QA from FCC on R4-40-900:

A) BLOCK DIAGRAM

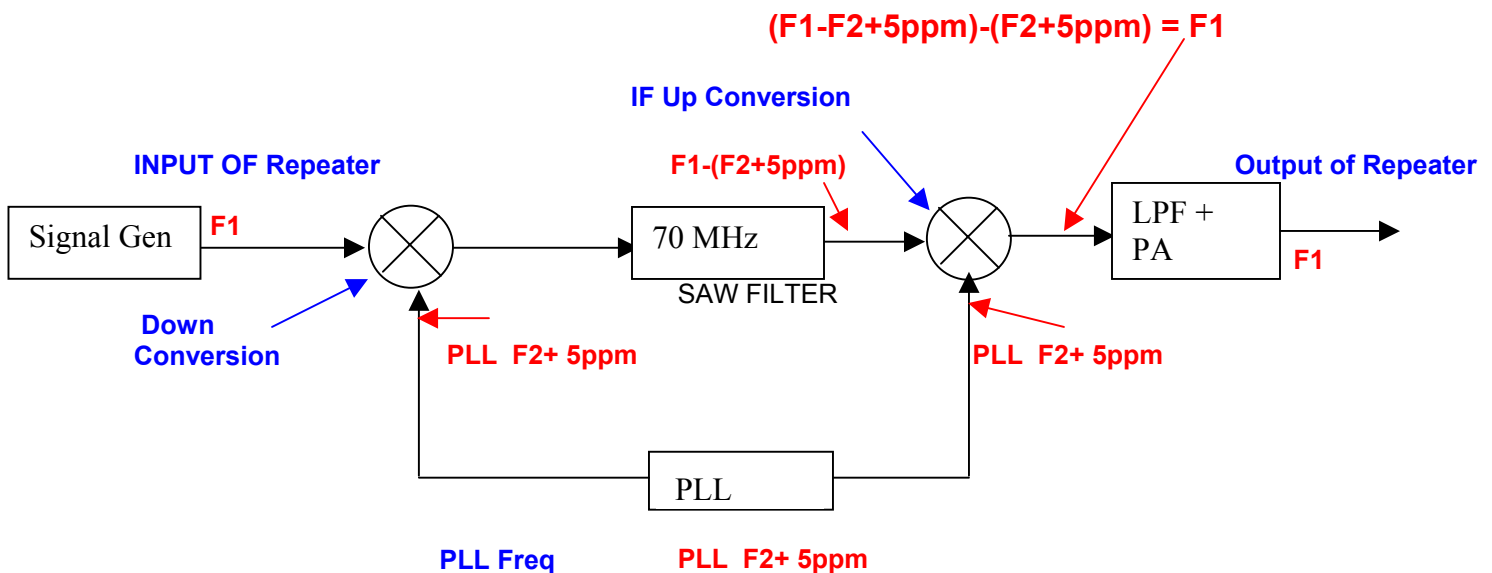
6. Additionally, the test report indicates that the Frequency Stability tests are not applicable. The Operational Description, Schematics and Block Diagram show that this device has frequency converters with Local Oscillators/VCO and mixers, even though there is no frequency

translation. Since this device does not have frequency generation/determining circuitry the frequency stability tests are applicable.

The design of repeater is taking care of this aspect.

For example : If F-1 is the frequency of signal generator fed to repeater input. This frequency is down converted using PLL freq F-2 to get IF of 70 MHz which is filtered using 70 MHz SAW filter. Now same PLL frequency F-2 is again mixed with filtered 70 MHz signal to up-converted back to F-1.

Now if PLL frequency changes by +5 ppm due to change in temperature to +55 degree C

THERE WILL BE NO CHANGE AT THE OUTPUT OF REPEATER w.r.t INPUT signal. This is explained below using block diagram

CASE-1 (@ temperature +55 deg C PLL frequency increased by +5ppm)

Here $F_1 - F_2 = 70 \text{ MHz}$
